City of El Paso – City Plan Commission Staff Report

Case No: SUSU14-00052 Painted Desert at Mission Ridge 1
Application Type: Major Preliminary
CPC Hearing Date: July 17, 2014
Staff Planner: Alfredo Austin, (915) 212-1604, austinaj@elpasotexas.gov
Location: West of Darrington and North of Paseo Del Este
Acreage: 50.468 acres
Rep District: N/A
Existing Use: ETJ/Vacant
Existing Zoning: ETJ
Proposed Zoning: ETJ
Nearest Park: 1 Park (4.26 acres) proposed within subdivision.
Nearest School: Dr. Sue Shook (PK-5) Elementary (0.25 miles)
Park Fees Required: N/A
Impact Fee Area: This property is not located in an Impact Fee Service Area.
Property Owner: State of Texas General Land Office
Applicant: Hunt Mission Ridge, LLC
Representative: CEA Group

**PAINTED DESERT AT
MISSION RIDGE 1**

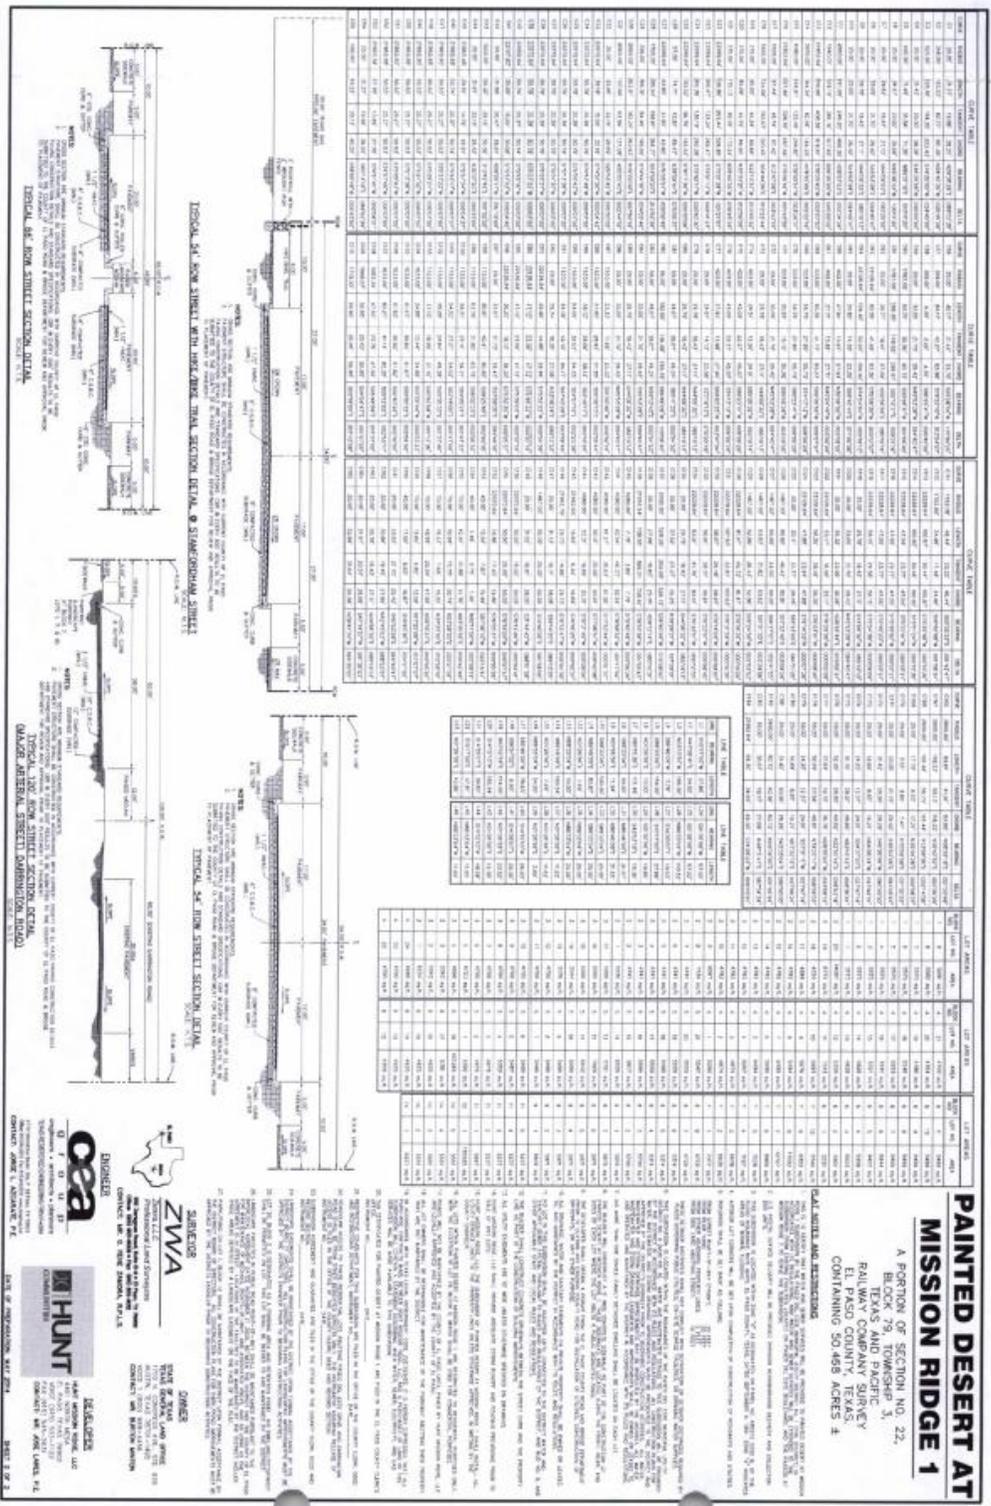
- Staff recommends that the City Plan Commission require that all parkways at the rear of double frontage lots be landscaped, to provide a visual and physical separation between the development and the street.

1. Provide complete Water and Sewage Facilities, and Drainage Engineering Report for ETJ requirements in English and Spanish.
2. Provide Final Engineering report notes for subdivision.
3. Label street classification on each of the typical street cross section details.
4. All storm water management facilities from Unit 2 should be in place prior or concurrently with development of the subject subdivision.
5. As per section Code 18.08.010, section D, all drainage structures and ponding areas serving the subdivision are constructed as part of the initial phase of the development.
6. Label whether drainage systems within Lot 18, between Lots 5 & 6 in Block 6 are public or private / a ROW or Easement.

The El Paso County 911 District requests that an address be assigned to Lot 18 in Block 6.
